Posted
Amdt. 122
to DPR-56

The Commission has issued the enclosed Amendments Nos. 118 and 122 to Facility Operating Licenses Nos. DPR-44 and DPR-56 for the Peach Bottom Atomic Power Station, Units Nos. 2 and 3. These amendments consist of changes to the Technical Specifications (TSs) in partial response to your application dated November 18, 1985.

SAFETY EVALUATION BY THE OFFICE OF NUCLEAR REACTOR REGULATION

PEACH BOTTOM ATOMIC POWER STATION, UNITS NOS. 2 AND 3

FIGURE 6.2-1

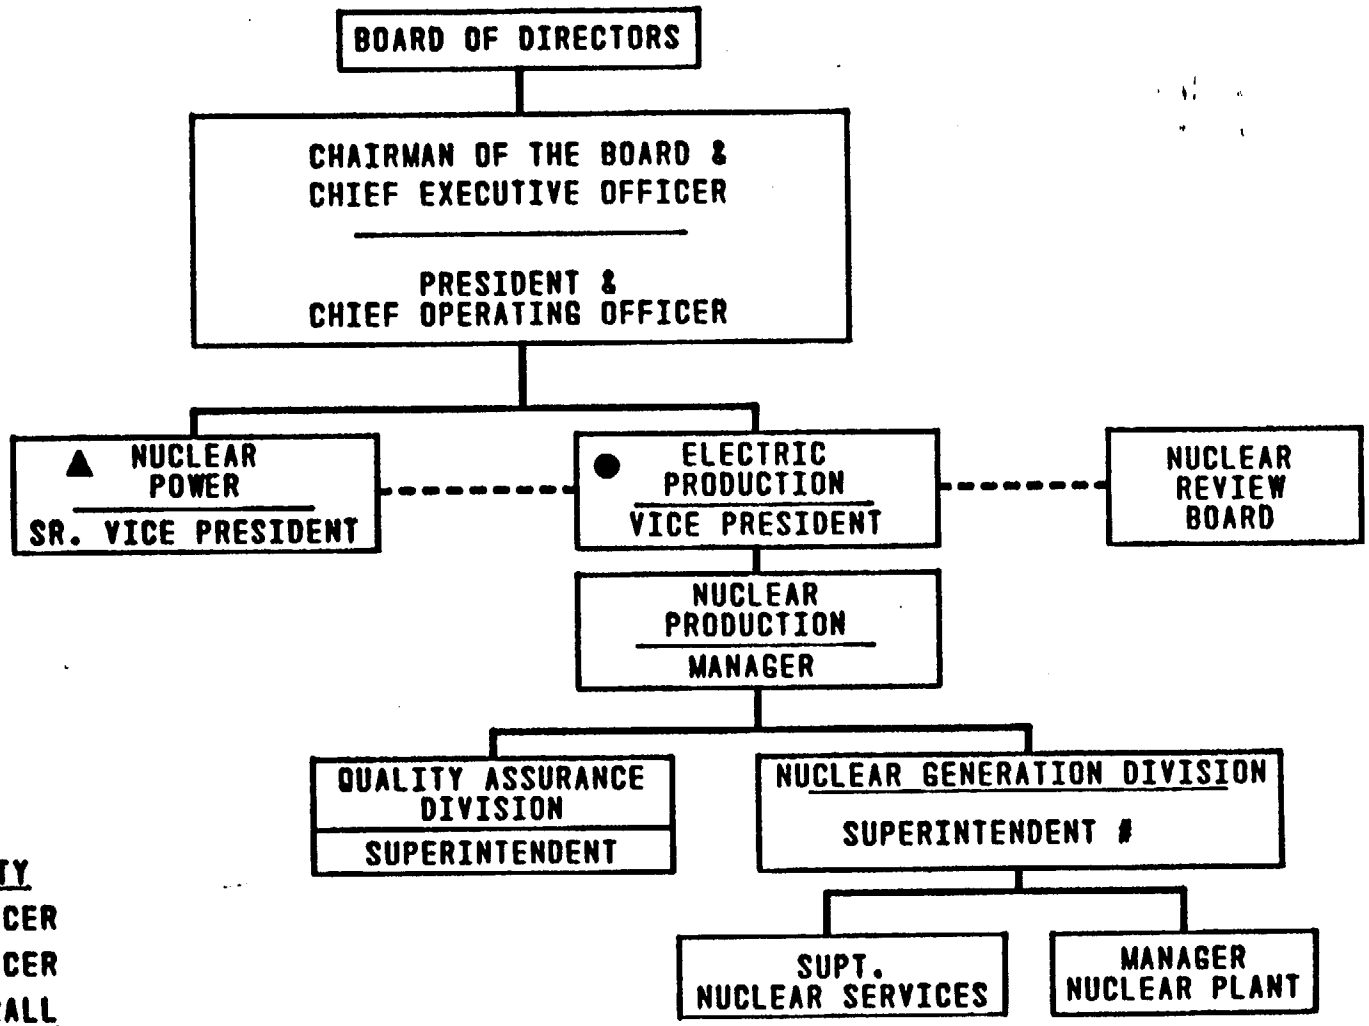
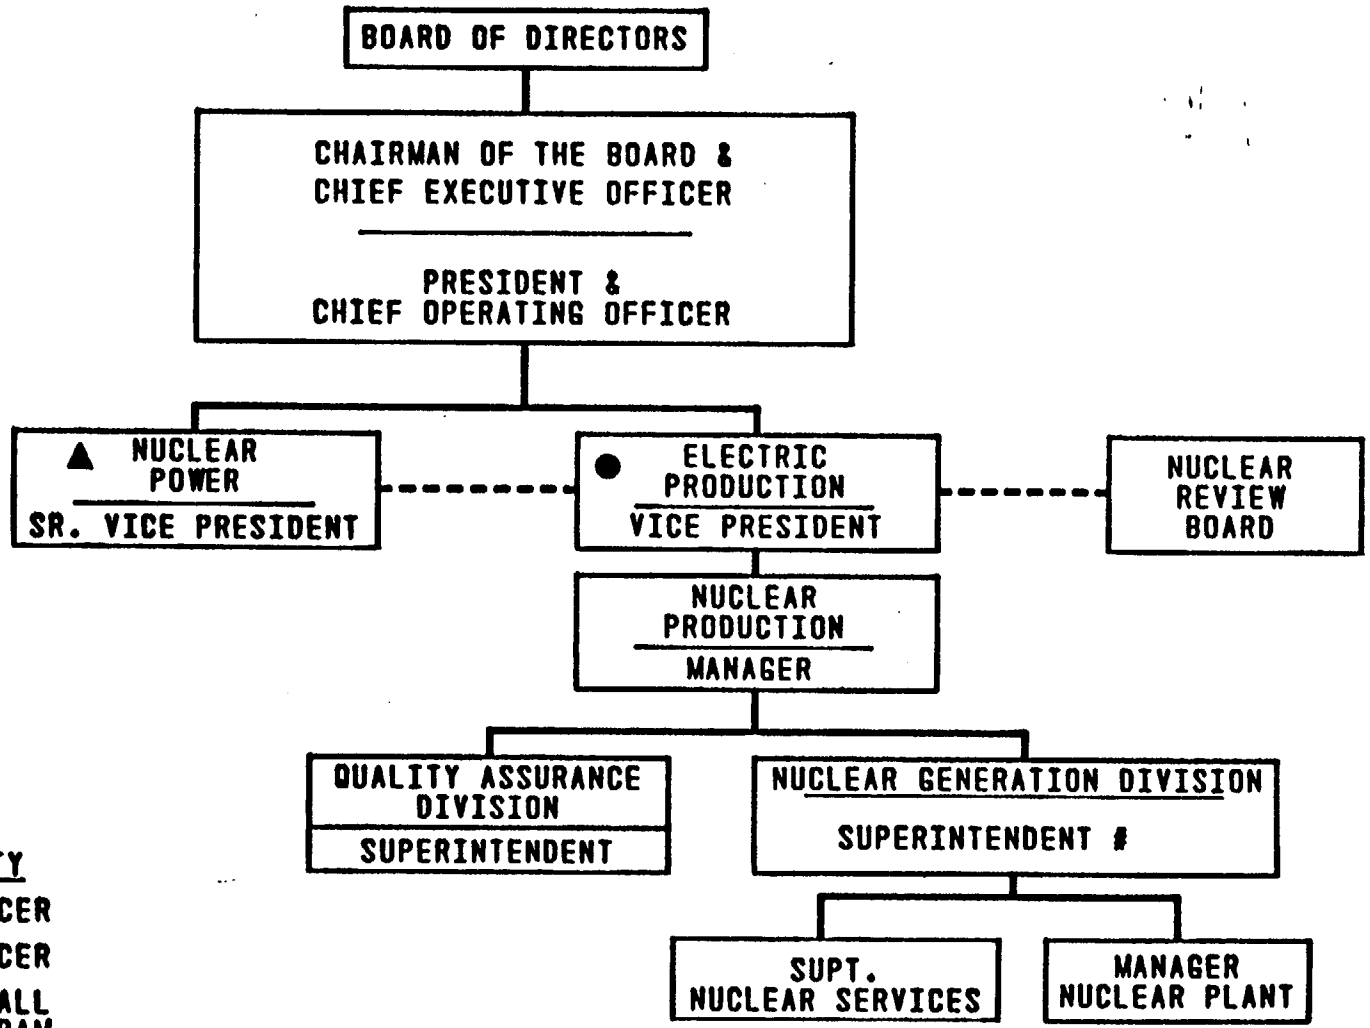
The proposed revisions to Figures 6.2-1 and 6.2-2 of the TS would change the title of "Station Superintendent" to "Manager-Nuclear Plant" and would create two new positions: Superintendent-Operations and Superintendent-Plant Services at the superintendent level to handle the plant management responsibilities previously handled in a single line organization through an Assistant Superintendent to the Station Superintendent. The Superintendent-Operations would manage the Senior Chemist, Technical Engineer and Operations Engineer. The Superintendent-Plant Operations would manage the Outage Planning Engineer, Maintenance Engineer and Senior Health Physicist.

In addition to the proposed changes previously described in Figure 6.2-1, the Management Organization Chart is revised to depict the splitting of the Generation Division into separate Fossil/Hydro and Nuclear groups, and the formation of a Nuclear Services group. The NRC was previously informed of this reorganization in letters dated April 4, 1983 and May 29, 1984.

The staff finds this proposed change to be acceptable since it conforms to Section 13.1.1 of the SRP.

FIGURE 6.2-2
ORGANIZATION FOR CONDUCT OF PLANT OPERATIONS
PEACH BOTTOM ATOMIC POWER STATION

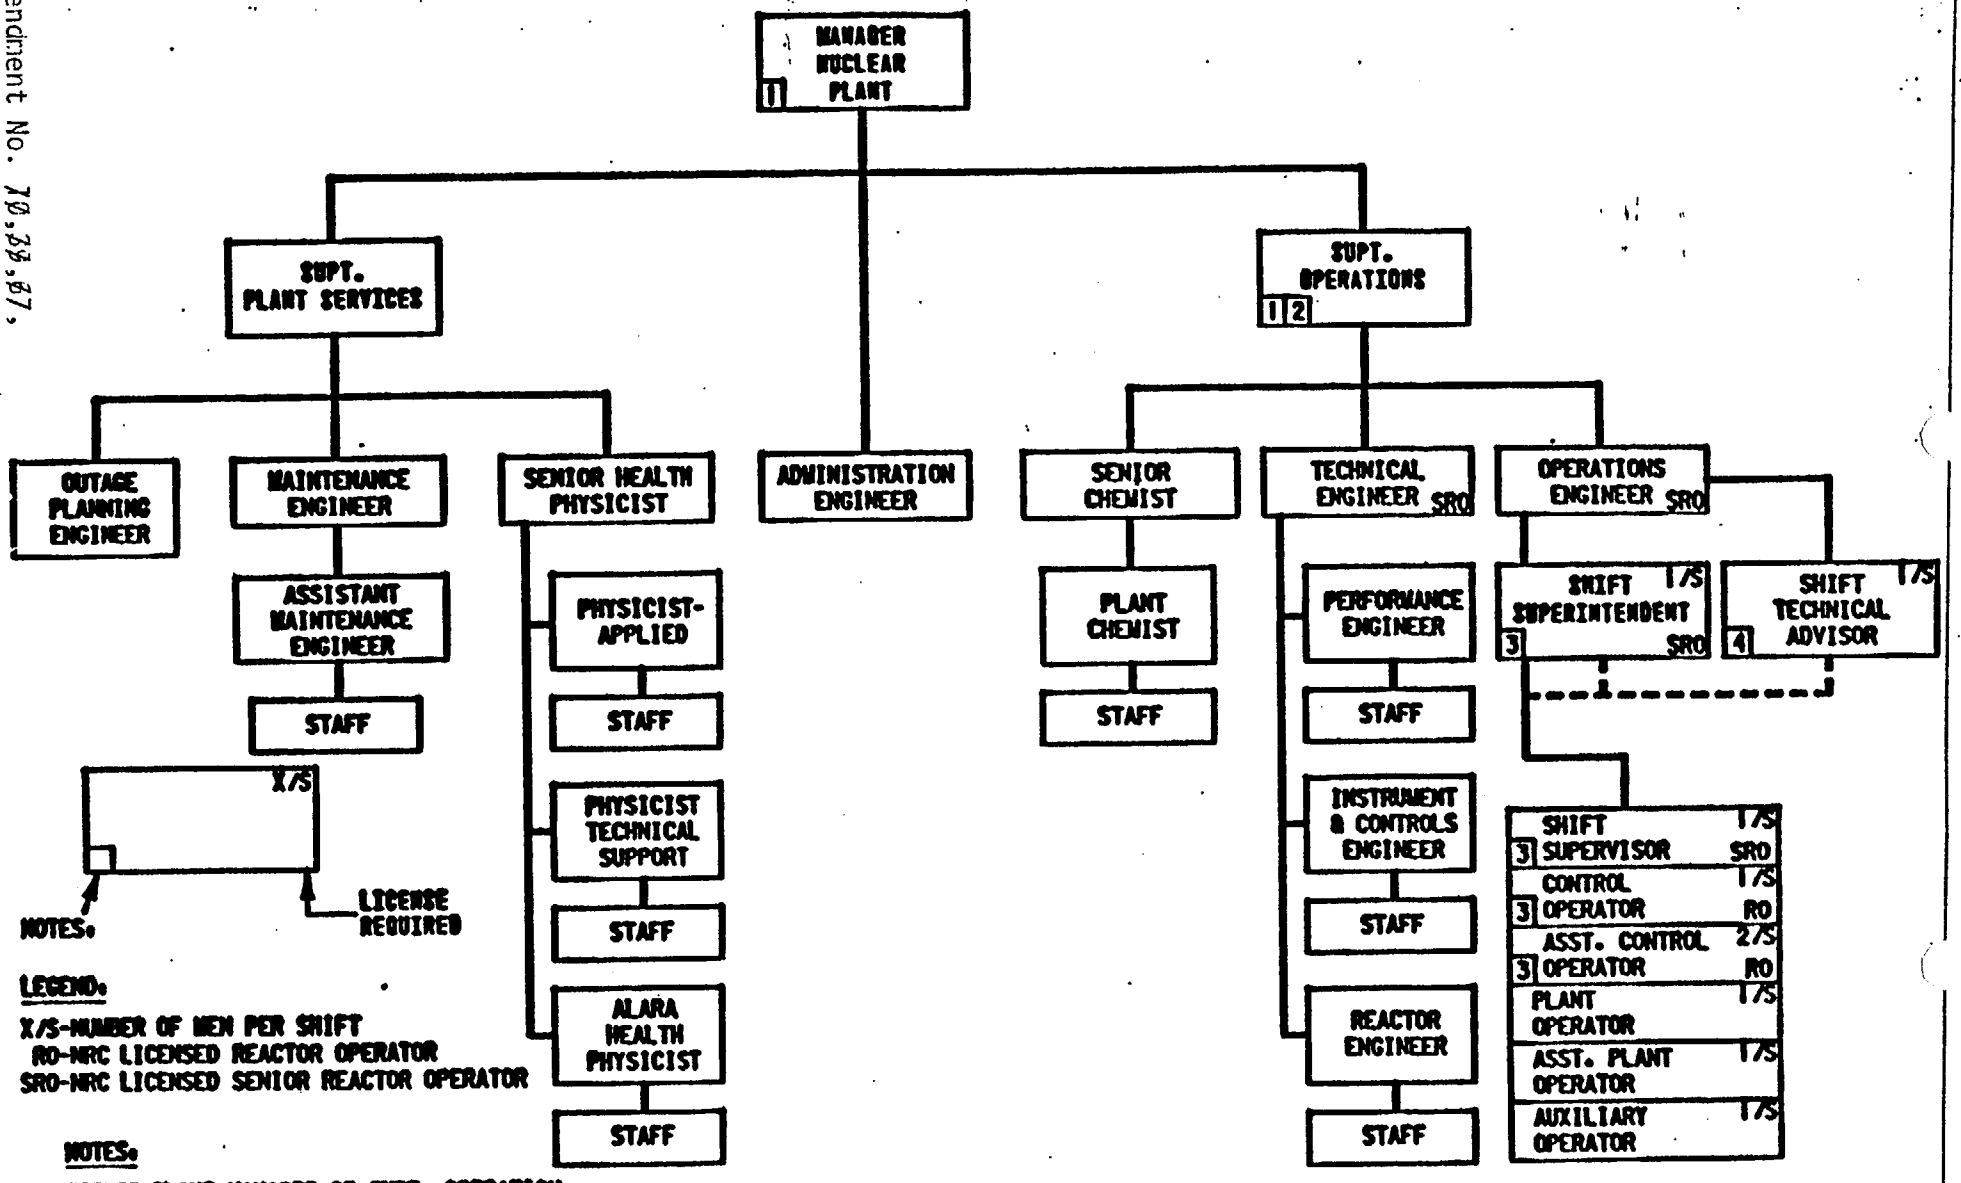
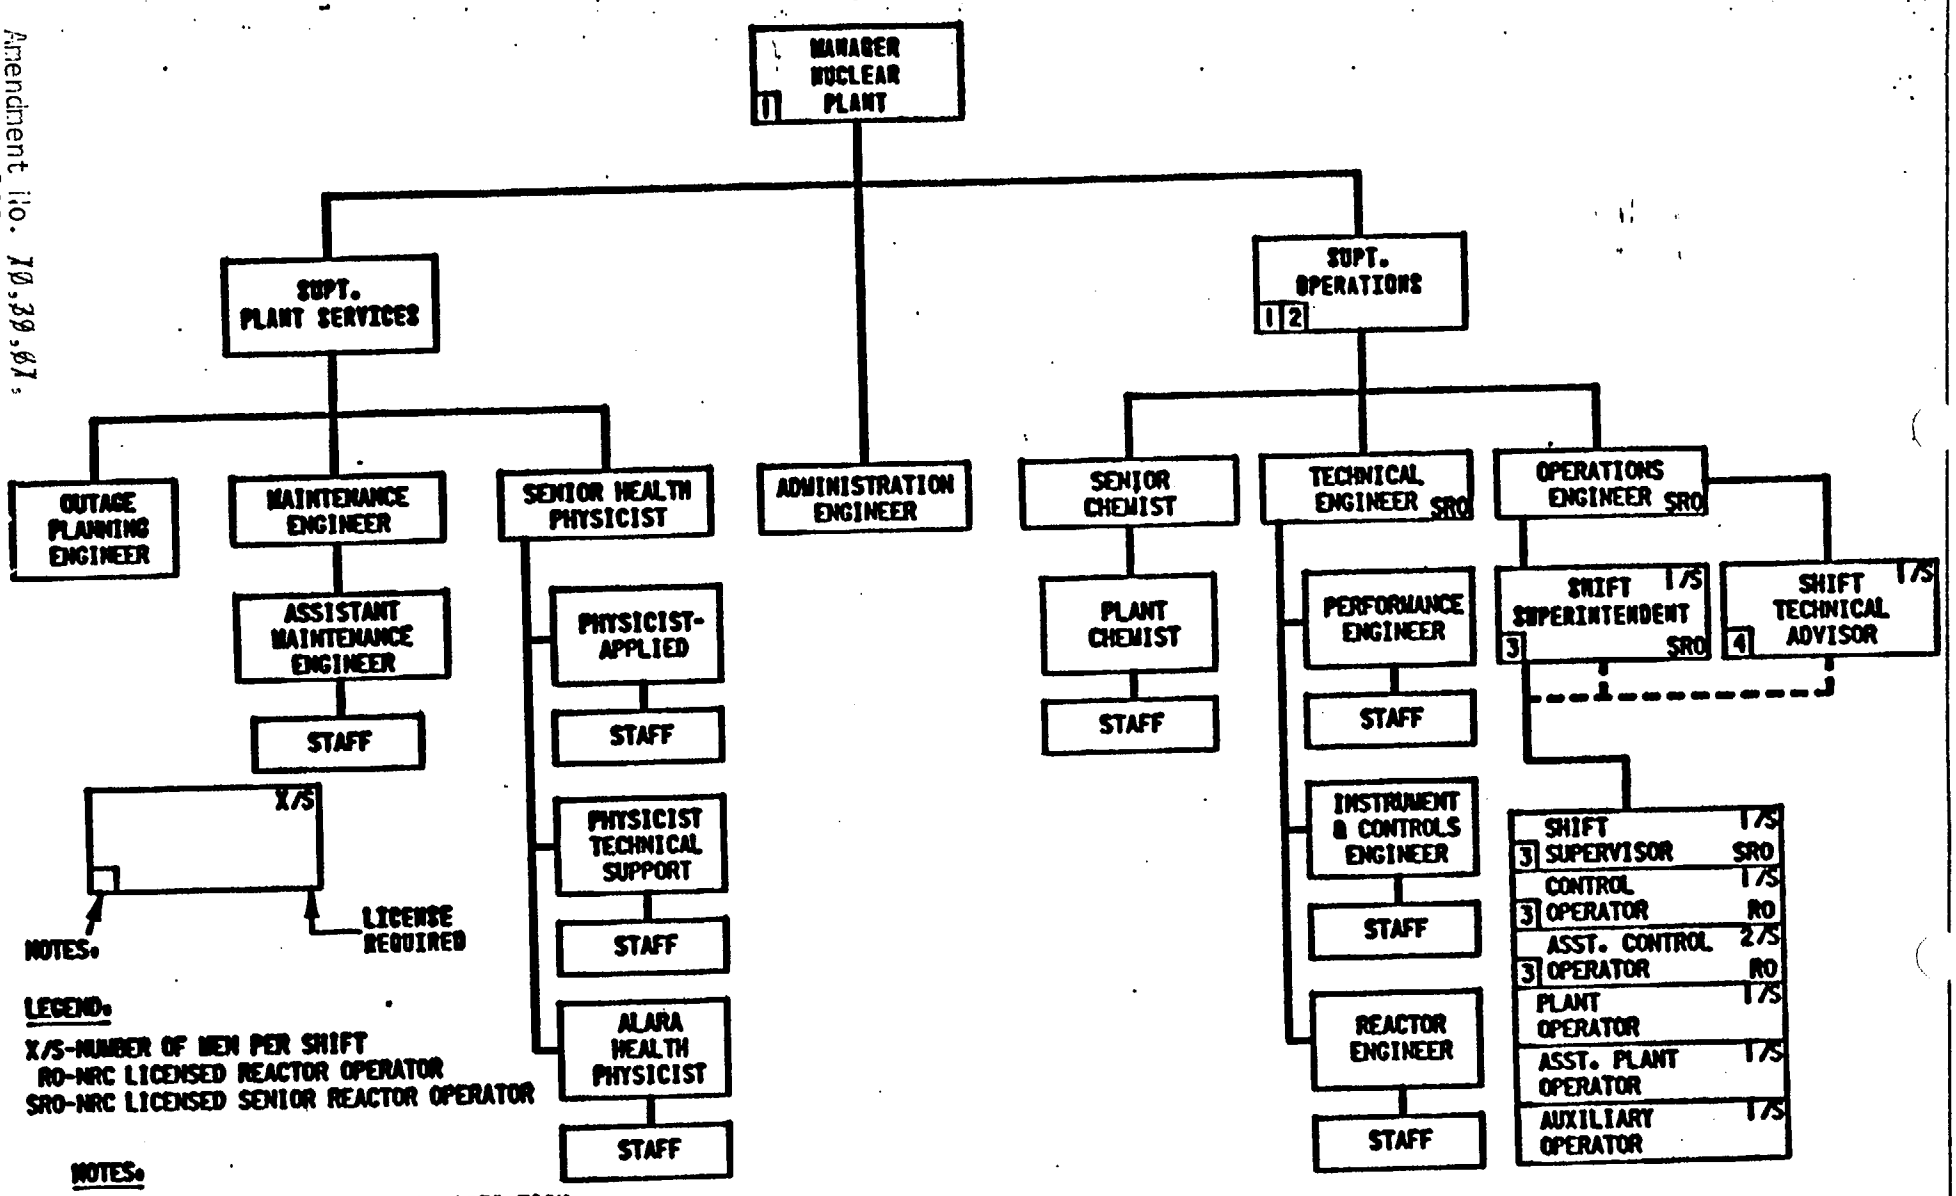
The proposed change to Figure 6.2-2 of the TS would divide the Health Physics and Chemistry programs into two groups, each directed by a senior level supervisor. Health Physics activities would continue to be supervised by the Senior Health Physicist. A new position of Senior Chemist would be established with the responsibility for the supervision of the radiochemistry and conventional chemistry activities. The Plant Chemist, who formerly reported to the Senior Health Physicist, would, under the new organization, report to the Senior Chemist.

The revised organization chart in Figure 6.2-2 would use a new format to improve clarity and depict the plant organization more accurately. The features of the new format are as follows:

The proposed revisions to Figure 6.2-2 of the TS would add the following four positions to the PBAPS organization chart: Administration Engineer, Assistant Maintenance Engineer, Outage Planning Engineer, and ALARA-Health Physicist.

The proposed change, as stated in Note 3 of Figure 6.2-2, would reduce the requirements to one Senior Operator and two Operators during periods when Peach Bottom, Units 2 and 3, are both in the shutdown or refuel mode. The change would permit the reassignment of these licensed personnel during a dual plant outage to support core alterations and other outage activities that require their expertise.

By letter dated March 18, 1985 (J. F. Stolz, NRC, to E. G. Bauer, Jr., PECo), the NRC suggested that the organization charts for Peach Bottom and Limerick be consistent. Accordingly, the following proposed revisions would be made to Figure 6.2-2 of the TS:

These proposed changes improve clarity and are revisions in nomenclature. Therefore, the staff finds that the revised Figure 6.2-2 is an acceptable organization chart since it shows the organization for conduct of plant operations at PBAPS and indicates the titles of the positions specified in Section 13.1.2 of the SRP.

The proposed staffing requirements are consistent with the Commission's regulations specified in 10 CFR 50.54(m)(2). Therefore, the staff finds this proposed change to be acceptable.

FIGURE 7.1-1

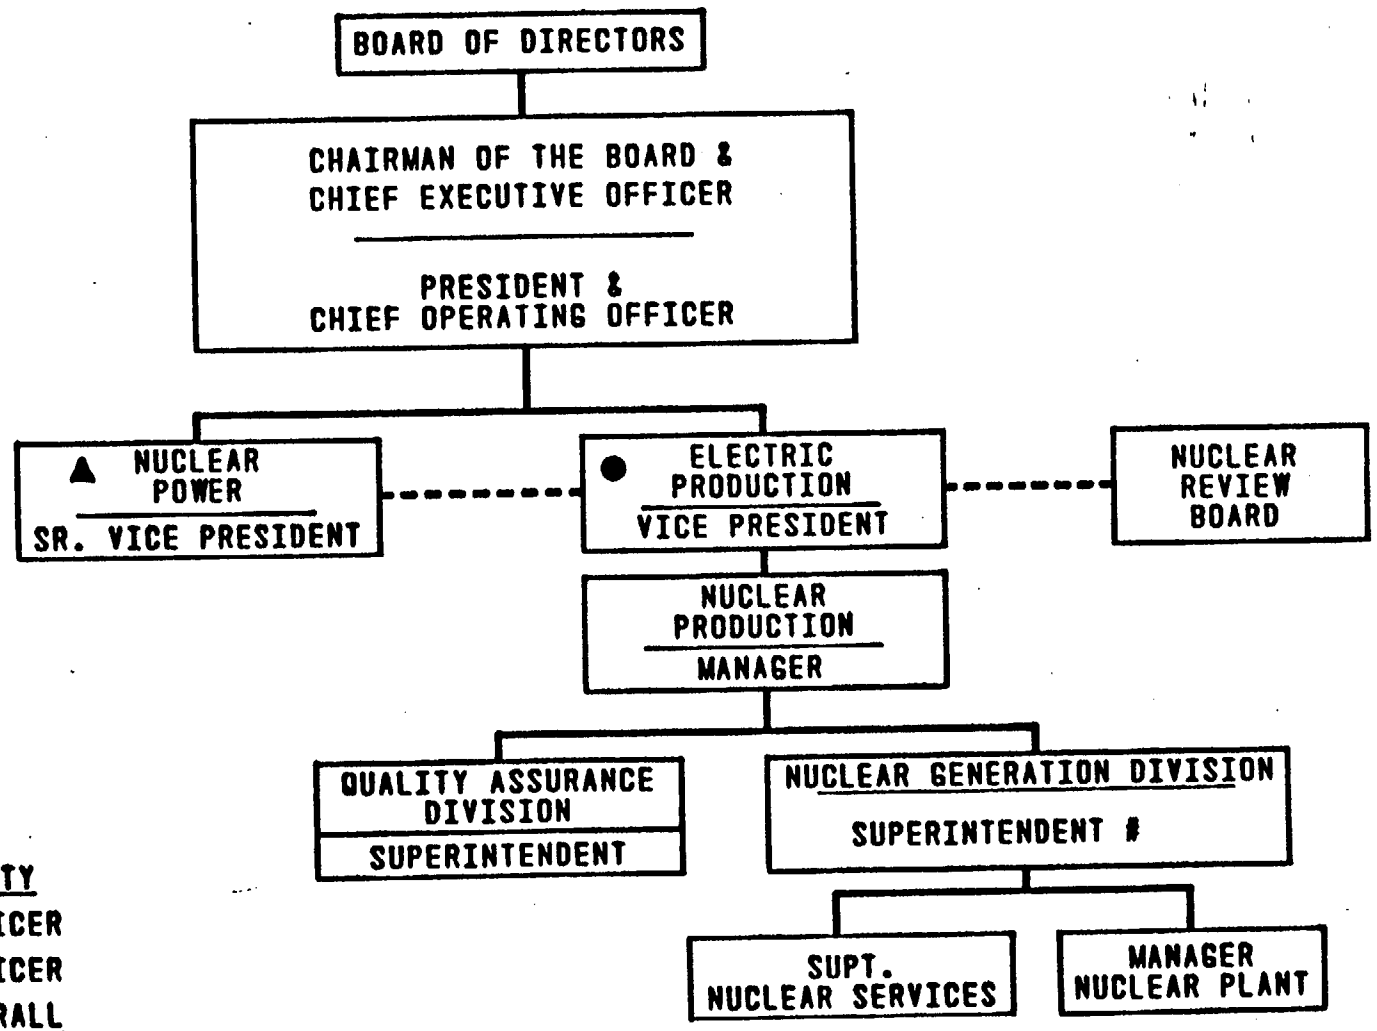
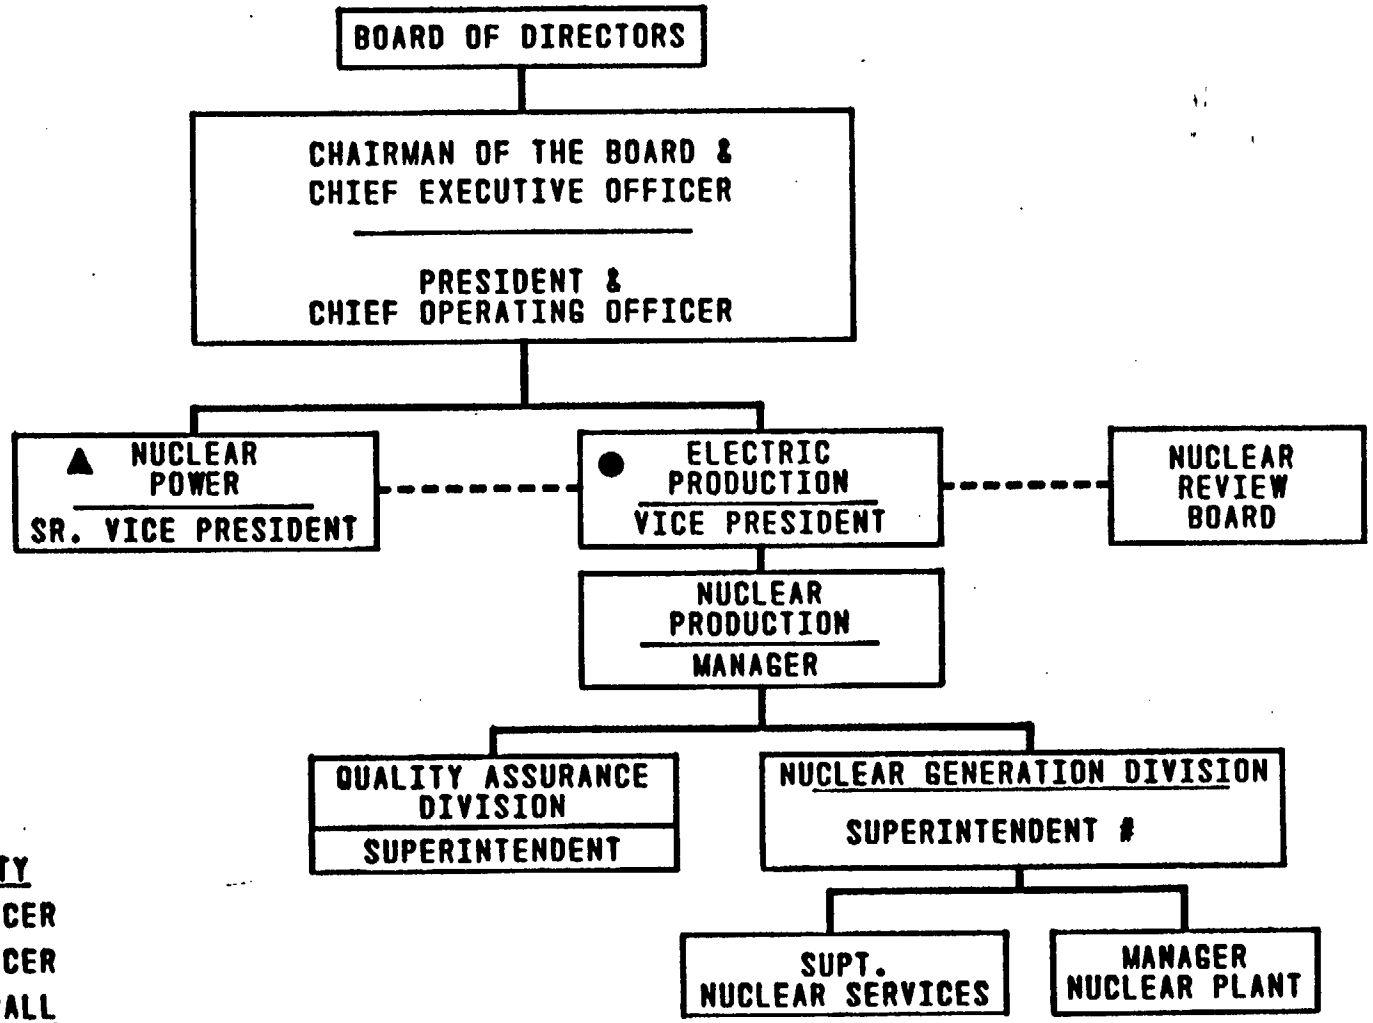
The proposed changes to the organization charts on Figures 6.2-1, 6.2-2 and 7.1.1, and to pages 243, 246, 247, 248 and 254 of the TS would reflect the following title changes: "Station Superintendent" to "Manager-Nuclear Plant" and "Results Engineer" to "Performance Engineer." These represent only changes in nomenclature and the responsibilities of these two positions remain unchanged.

Because these proposed changes involve only title revisions, the staff finds that these changes are acceptable.
